Attachment E

Original Planner's Report

Item 6.**Development Application: 21 O'Connor Street, Chippendale****File No.:** D/2018/1360**Summary****Date of Submission:** 8 November 2018**Applicant:** Kreis Grennan Architecture**Architect/Designer:** Kreis Grennan Architecture**Owner:** Anthony Rodgers and Bernadette Mullin**Cost of Works:** \$611,128**Zoning:** The use is defined as commercial and residential and is permissible in the B4 Mixed Use zone.**Proposal Summary:** The application proposes alterations and additions to the existing mixed-use warehouse building to include a new commercial studio, courtyard and garage on the ground floor, internal reconfiguration of the first floor, extension of the second floor onto the existing outdoor terrace, and addition of a roof terrace above.

Figure 4: Proposed ground and first floor plans

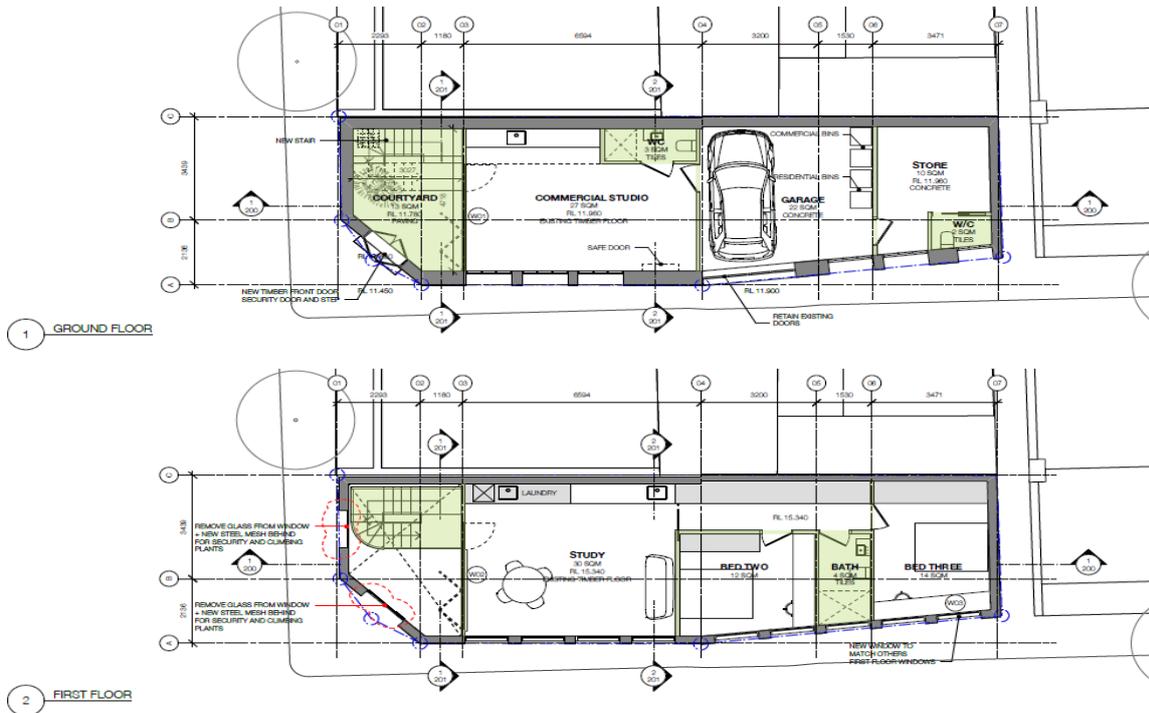
4.2.3 Amenity	Partial compliance	<p>As discussed earlier in the report, each of the three levels are accessible from the internal courtyard via an external stair and are capable of being self-contained, with no internal connectivity. Each of the three levels provide acceptable internal amenity in regards to solar and daylight access, natural ventilation, ceiling heights, size and layouts, access to private open space and storage. The subdivision of the building was not sought under this application.</p> <p>Solar Access</p> <p>The shadow diagrams show additional overshadowing to the front private open space and windows of the properties opposite Smithers Street at 10.00am and the private open space of the eastern neighbours at 3.00pm. It is noted that the extent of additional shadows cast by the proposal is minor, and that the affected properties maintain a minimum of two hours solar access, as per DCP requirements. The shadow diagrams show additional overshadowing to the roofs of various neighbouring properties at different stages of the day. As such the proposal is not considered to result in significant adverse impacts in relation to solar access.</p> <p>Privacy</p> <p>The proposal includes a roof terrace above the new addition, which will result in unacceptable privacy impacts to the neighbouring private open space and is inconsistent with DCP provisions. Refer to Figure 14.</p>

Figure 5: Proposed second floor and roof terrace plans

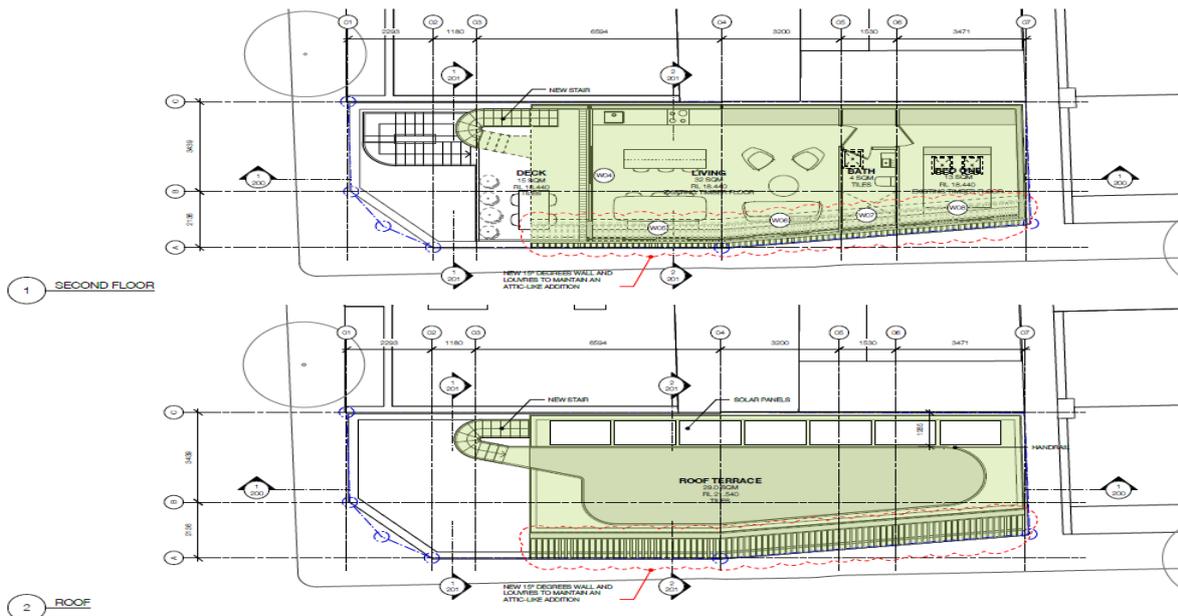
62. The addition is not recessed from the parapet to the building and still presents as a third storey, failing to comply with the LEP and DCP height controls. The proposal is considered to be unsympathetic to the character, scale and form of the existing building and surrounding buildings within the heritage conservation area. The site is adjoined by two storey terrace rows to the north, south and east.

63. The roof terrace will result in an unacceptable privacy impact, and the external stair and balustrade create additional bulk and overshadowing. As illustrated in Figure 13, the roof terrace overlooks the private open space of several neighbouring properties.

Figure 13: The applicant's FSR calculations showing existing FSR (left) and proposed FSR (right). FSR is shown in red and private open space in blue.

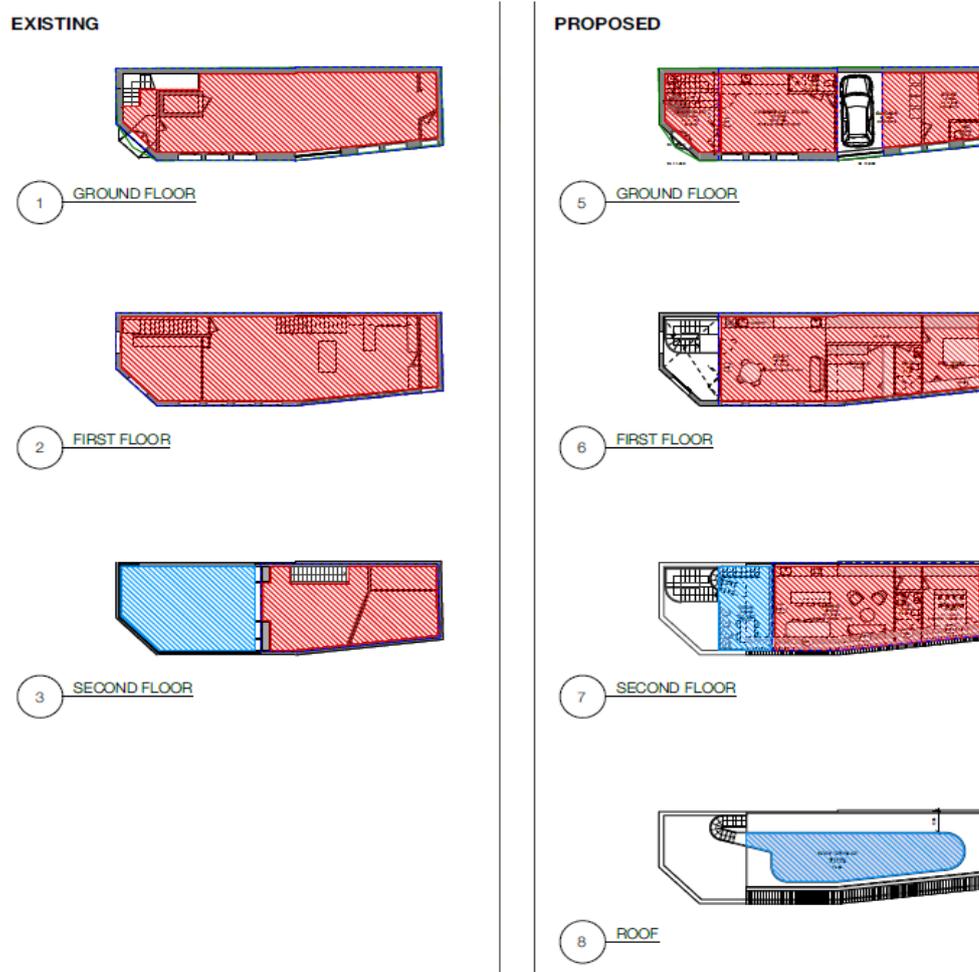
41. The site is subject to a floor space ratio control of 1.5:1. The proposed development has a floor space ratio of 1.93:1.
42. The existing building has an FSR of 2.11:1. The proposal results in a net decrease of 16.52sqm of floor space as a result of the creation of a void at the first and second floor and provision of a car parking space within the ground floor. Despite the reduction in floor space, the development still represents an exceedance of 0.43:1 (25% over the standard).

47. The written request has failed to demonstrate that the objectives of the floor space ratio development standard are achieved notwithstanding the non-compliance with the standard, in particular Clause 4.4(1)(d), which requires new development to reflect the desired future character of the locality and minimise adverse impacts on the amenity of the locality.
48. The development results in a small reduction in overall FSR due to internal changes on the ground and first floor levels. Notwithstanding, the proposal results in increased bulk at the third storey which is considered to result in an unsympathetic built form. Furthermore, the roof terrace above, is likely to result in significant privacy impacts to the neighbouring properties.
